**Re: LHM Jeep Dodge
909 Virginia NE
Traffic Circulation Layout**
Engineer's/Architect's Stamp dated 3-31-16 (K19-D023)

RE: LHM Jeep Dodge Albuquerque
TCL City Review Comments
February 3, 2016

Traffic Circulation/Site Plan

CO.1

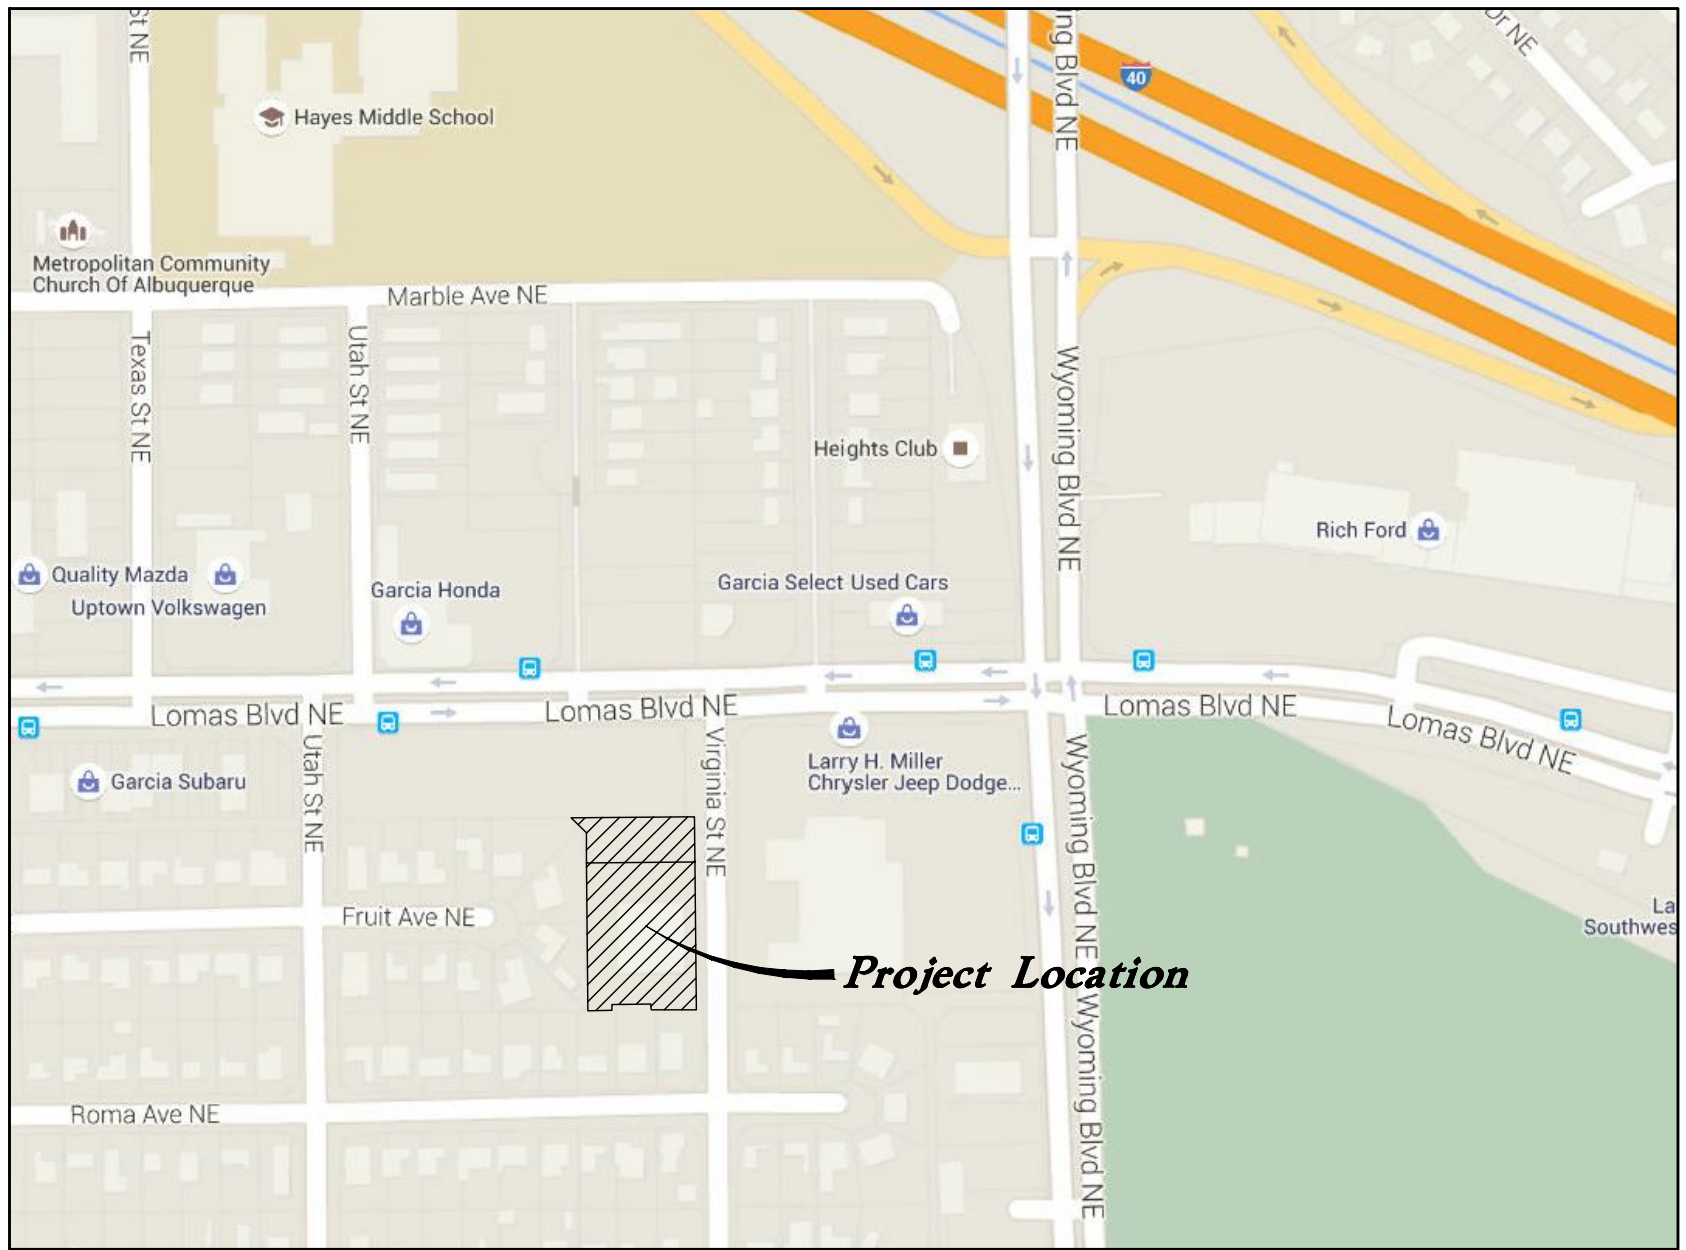
Comment 11: Unused curb cuts must be replaced with sidewalk and curb & gutter. A build note must be provided referring to the appropriate City Standard drawing.

Response: Sheet C0.1, Demolition Plan, shows the removal of the unused curb cuts and sidewalk to be removed. Sheet C1.1, shows the callouts for replacing the curb, gutter and sidewalk. Sheet C3.2, detail 11, Albuquerque Standard Drawing 2430 is the detail for the sidewalk. Sheet C3.2, detail 13, Albuquerque Standard Drawing 2415A is for the curb and gutter.

C1.1

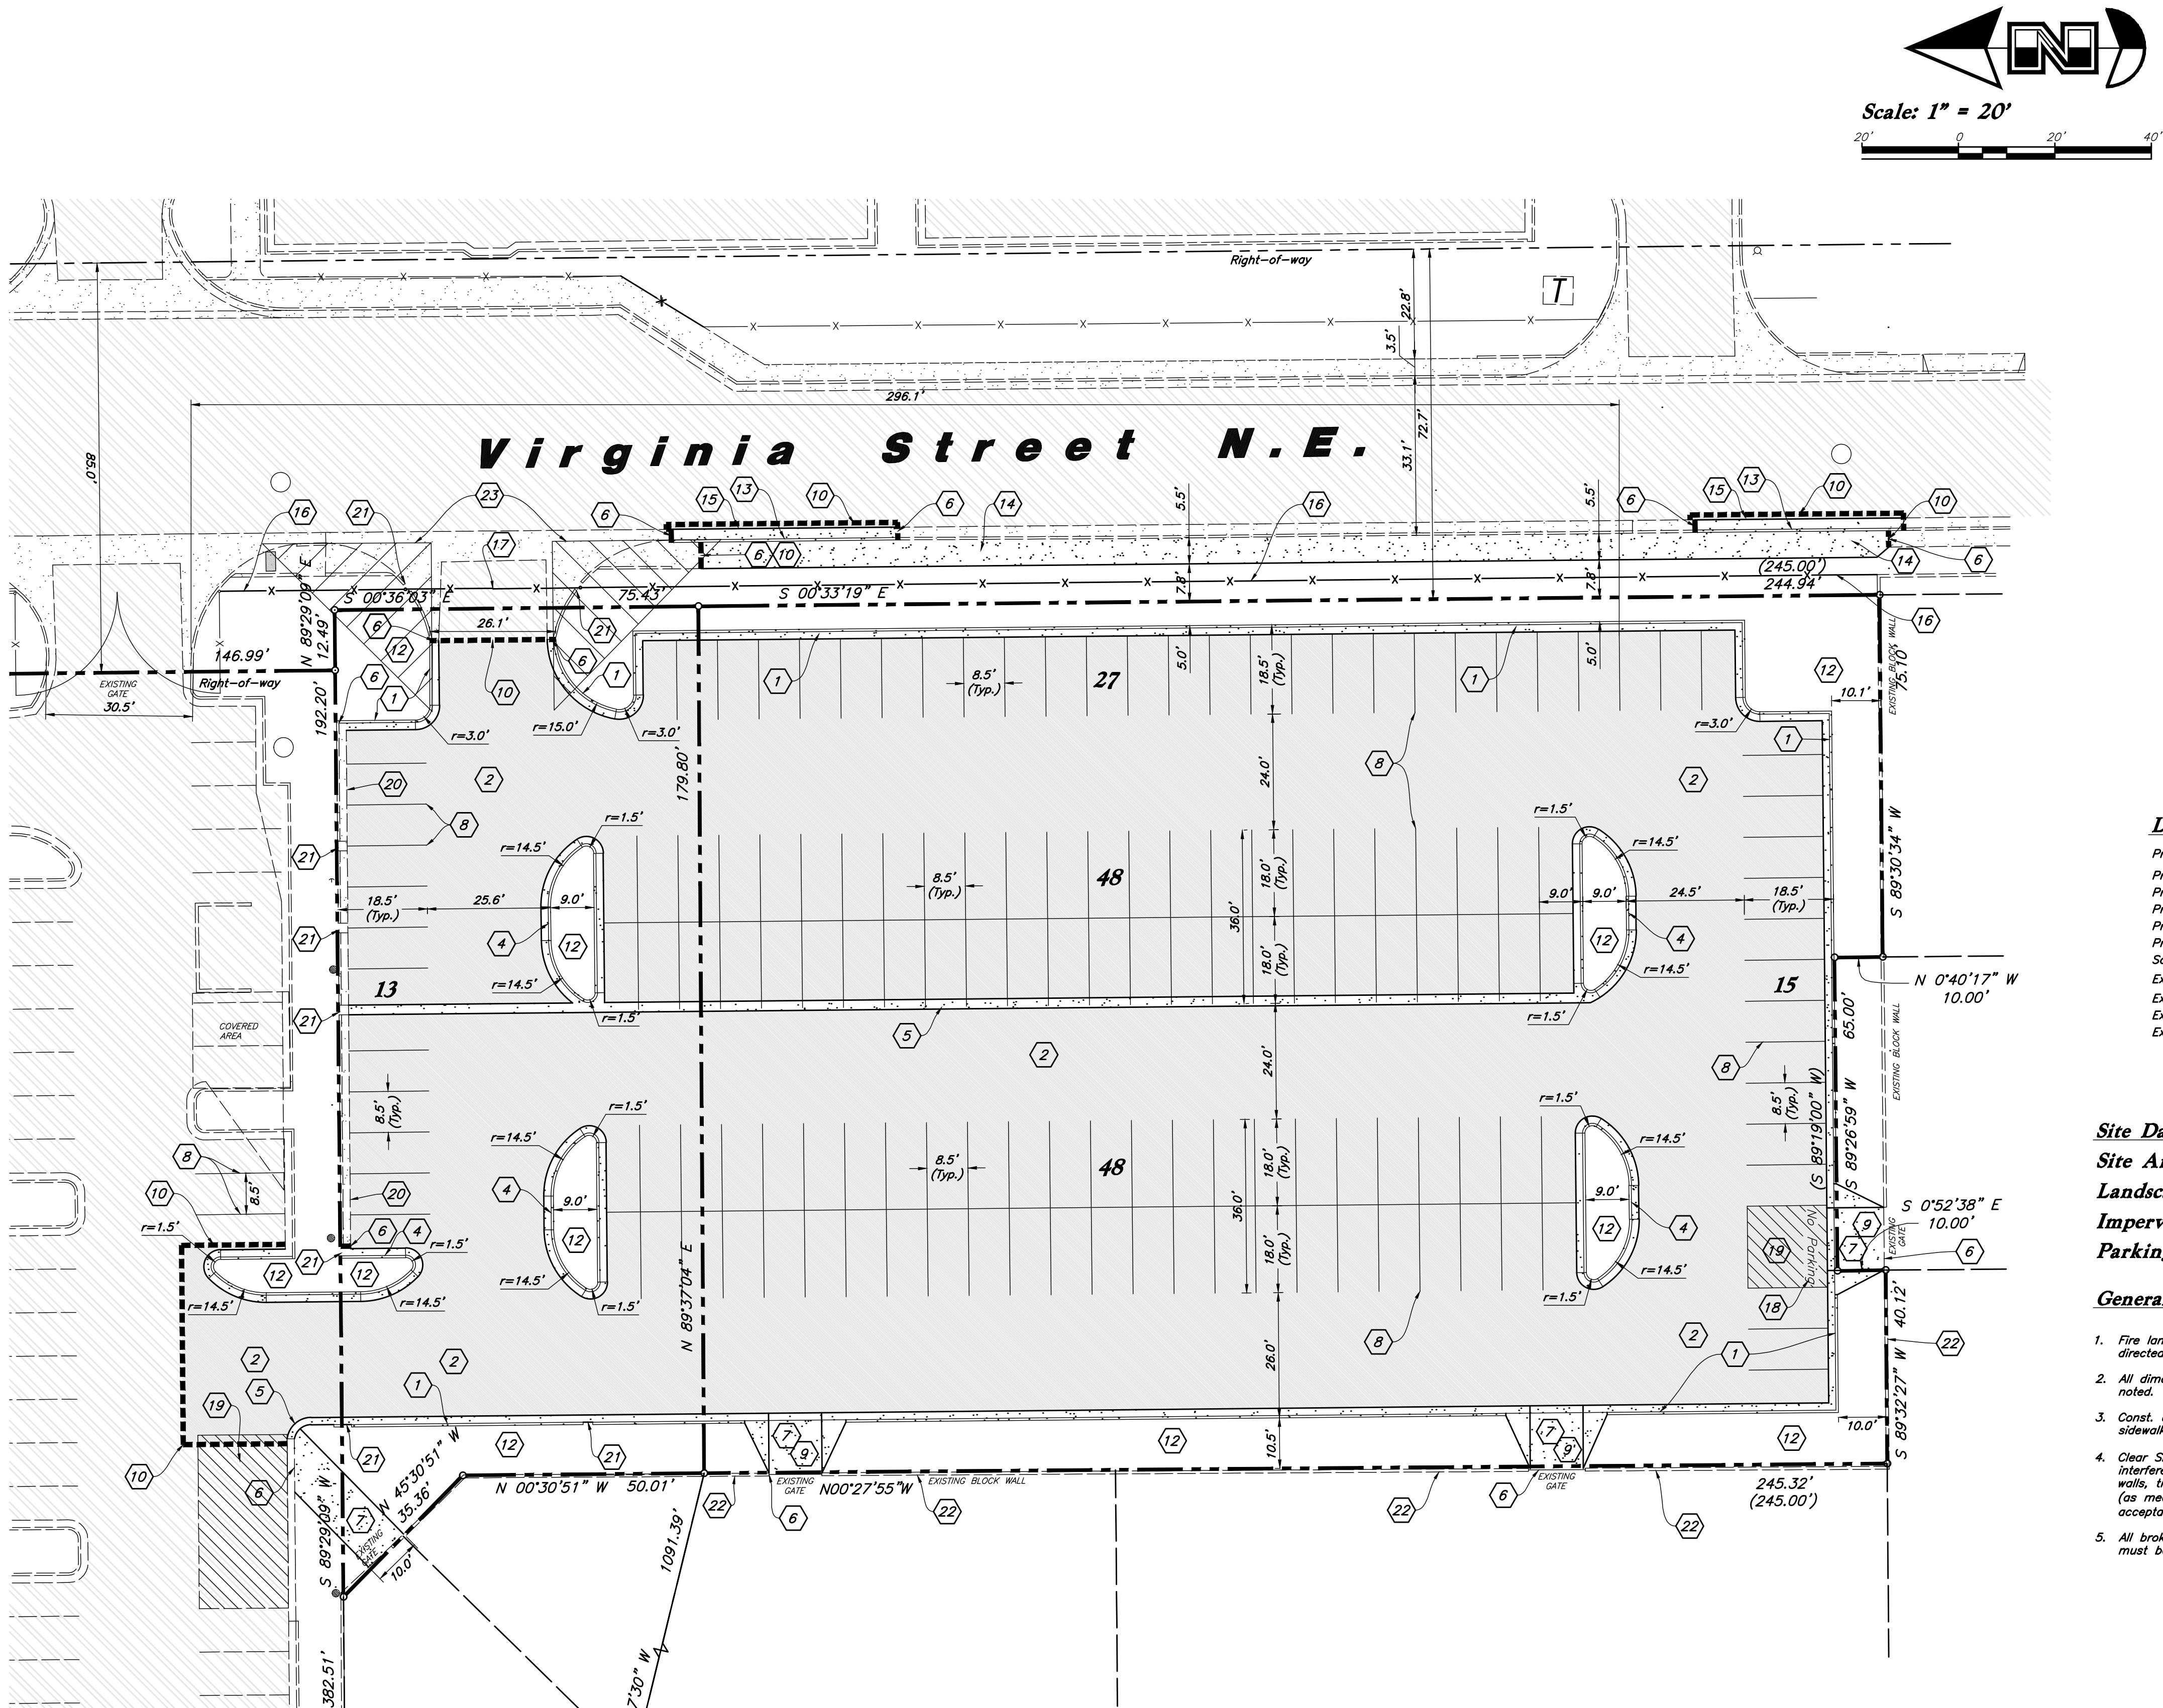
Comment 1: List the number of parking stalls required by the zoning code as well as the proposed number of parking spaces.

Comment 3: Please identify and dimension sidewalks, curbs, drive pads, walls and anything that influences the parking and circulation on the site. Dimension the drive pad entrances to the proposed parking lot from Virginia St. and from the proposed entry at the northwest corner.

Comment 4: Identify the right of way widths, medians, curb cuts, and street widths on Virginia St.

Comment 5: Please list the width for all parking spaces on the south side of the proposed parking lot.

Comment 7: Provide a min 6" or max 8" high concrete barrier curb or other acceptable barrier between landscaping and parking areas and/or drive isles. Please call this detail.

Comment 8: Please provide a sight distance exhibit (see the Development Process Manual, Chapter 23, Section 3, Part D.5 Intersection Sight Distance). Please call out this detail for the entrances/exits off of Virginia Ave.

Comment 9: Please add the following note to the clear sight triangle: "Landscaping and signage will not interfere with clear sight requirements. Therefore, signs, walls, trees, and shrubbery between 3 and 8 feet tall (as measured from the gutter pan) will not be acceptable in this area.

Comment 12: All Broken or cracked sidewalk must be replaced with sidewalk and curb & gutter. A Build note must be provided referring to the appropriate City Standard drawing.

Response: Information added to sheet C1.1, Site Data. The number of stall required is 0 and the number of stalls provided is 153 (for additional parking and inventory storage).

Response: Dimensions added to sheet C1.1.

Response: Dimensions added to sheet C1.1, right of way is 85' north of our site and 72.5' along our site.

Response: Dimension added to sheet C1.1, all parking stalls are 8.5' wide.

Response: Sheet C1.1 shows the curbs and the type. The curb details are on sheet C3.1, detail 1 and 6. A 24" Curb and Gutter is proposed for the south and west side of the paved area. And a rolled Curb and Gutter is proposed for the interior. The owner prefers Rolled Curb and Gutter because they don't scuff the tires of the new cars.
Also detail for the new curb along Virginia St. is added to plans. See Sheet C3.2, Detail 13, Albuquerque Standard Drawing 2415A.

Response: Sight distance exhibit, Clear Sight Triangle, is on sheet 3.1, detail 7. Sheet C1.1 shows the Clear Sight Triangles

Response: Note added to sheet C1.1, General Site Notes: note 4. (Clear Sight Triangle: "Landscaping and signage will not interfere with clear sight requirements. Therefore, signs, walls, trees, and shrubbery between 3 and 8 feet tall (as measured from the gutter pan) will not be acceptable in this area.)

Response: Note added to sheet C1.1, General Site Notes: note 5. (All broken or cracked sidewalk and curb & gutter must be replaced as per city standards.)
